5 NEWLANDS STREET, CHEVYCHASE
[HPG CASE # 35713-137]
CHEVYCHASE HISTORIC DISTRICT

MEMORANDUM

SUBJECT: Historic Area Work Permit #621792, roof replacement

MONTGOMERY COUNTY HISTORIC PRESERVATION COMMISSION
STAFF REPORT

Photo #9, garage roof facing East

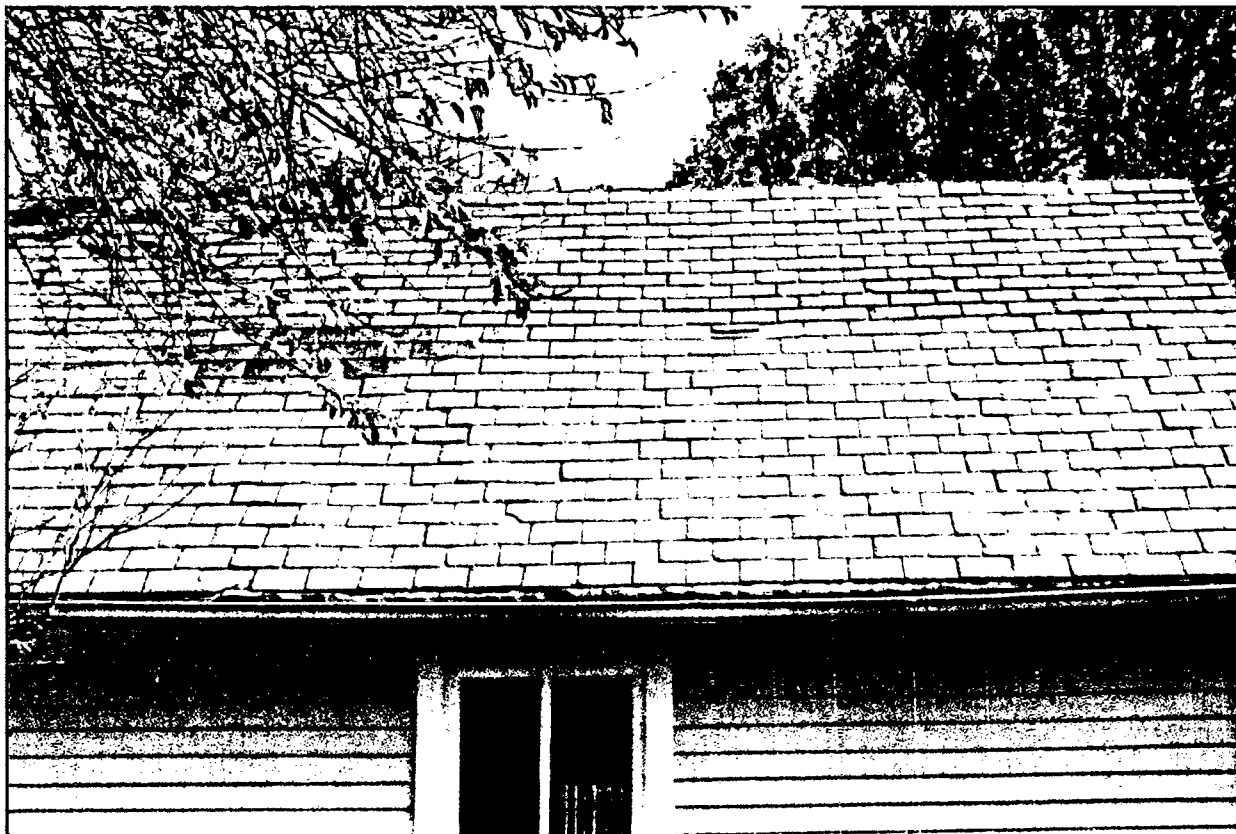
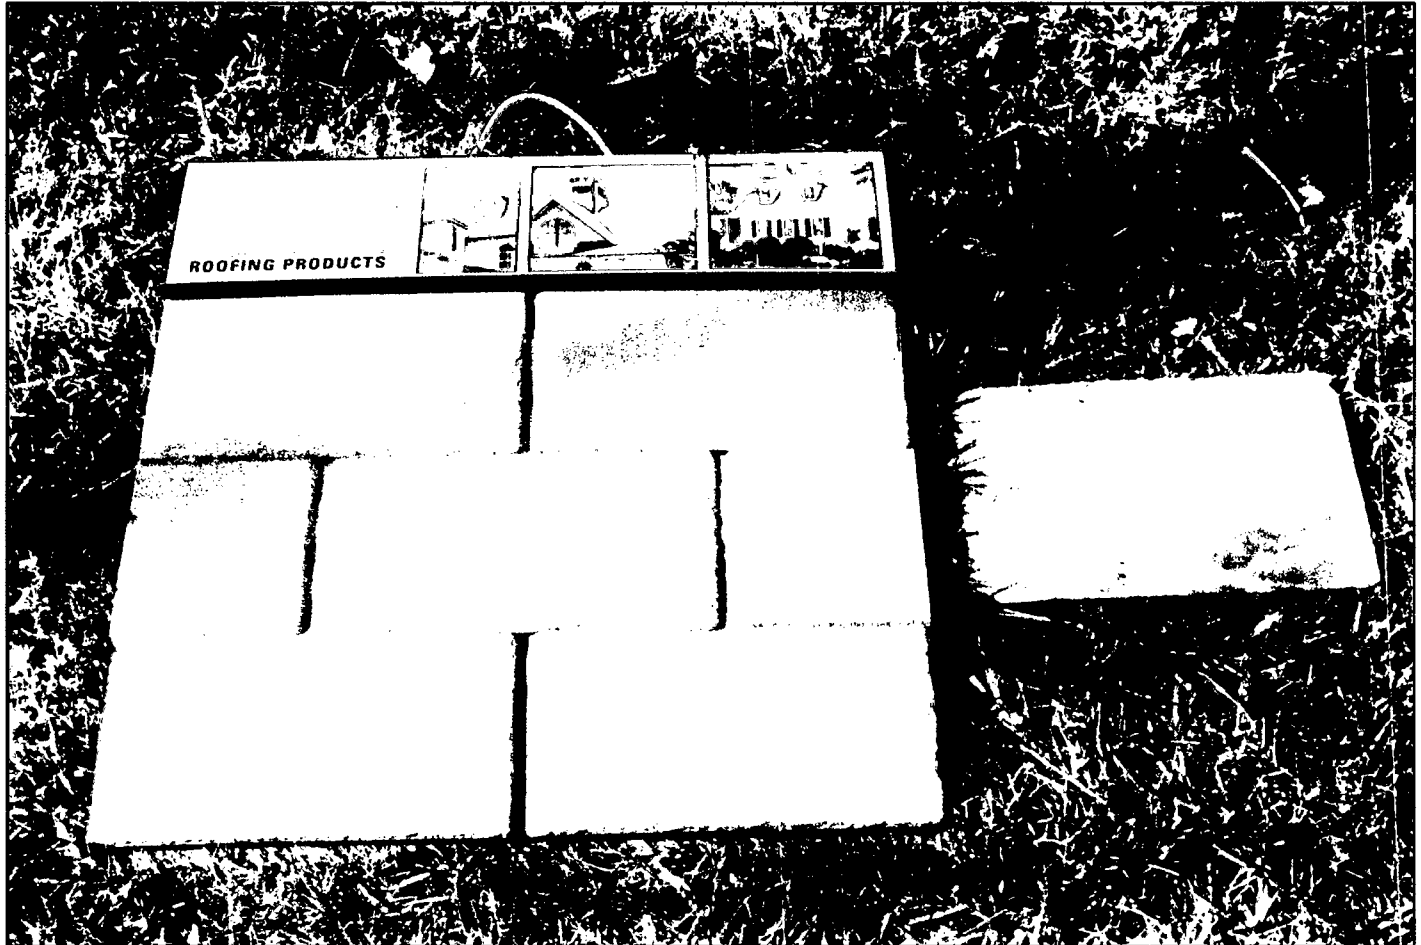
Staff recommends approval, but with retention of salvageable slate for use on the garage.

LAP believes that staff approval is appropriate for replacement with composite slate, but we do not see the need to reuse the old slate unless the owner has a preference to reuse it:

The staff's recommendation to "condition" approval of this application on using original building materials for the garage roof would be a direct violation of the Master Plan. The applicants' proposal to use compatible new materials is clearly and unequivocally permitted by the Master Plan guidelines quoted on page 2 of the staff's report, because the house and garage are contributing resources rather than outstanding ones. Therefore, the HPC has no authority to place any substantive condition on approval of any portion of the proposal, let alone a condition that itself directly conflicts with the Master Plan.

Even if the HPC had such authority, it would be inappropriate to do so here for three reasons. First, the garage is located at the rear of the property and most or all of its roof will not be visible from the public right-of-way. Second, there was historically a match between the roofing materials on the house and the garage, so it would be discordant to require a difference between the two. Third, the applicants have already shown laudable sensitivity to the character of the Village, at significant expense to them.

Sound salvageable red slates from the house and garage are consolidated and reinstalled on the garage.

Sound salvageable red slates from the house and garage are to be consolidated and reinstalled on the garage
